# UNITED STATES PATENT AND TRADEMARK OFFICE

10/561,725

<b>Office Action Summary</b>	<b>Application No.</b> 10/561,725	<b>Applicant(s)</b> PEIN, ANDREAS	
	<b>Examiner</b> JONATHAN W. MILES	<b>Art Unit</b> 3731

## **DETAILED ACTION**

**Image 1 from Gernlein Fig. 2**

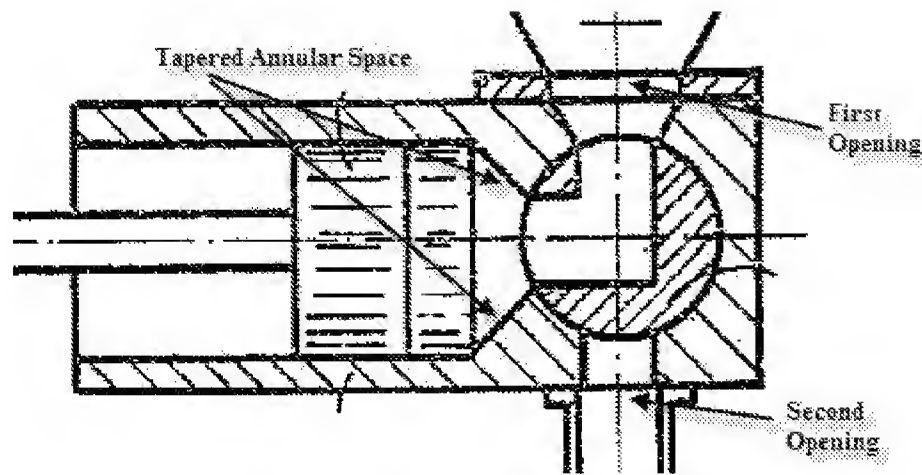
Regarding Claim 9, Yoder et al. in view of McDonnell et al. discloses the water jet apparatus according to claim 8, but does not disclose wherein at least a lowermost portion of the annular space tapers inwardly in a downward direction toward the suction-pressure space, the taper being formed by a frustoconical portion of the cylinder wall.

However, Gernlein discloses a fluid pump wherein the lowermost portion of the annular space tapers inwardly in a downward direction toward the suction-pressure space, the taper being formed by a frustoconical portion of the cylinder wall (see Image 1 above).

It would have been obvious to combine the tapered shape of Gernlein with the water jet apparatus of claim 8 because the shape prevents the piston from being extended any further. The motivation for the modification would have been to create a stop for the piston prior to extending all the way until it reaches the lowermost portion of the annular space.
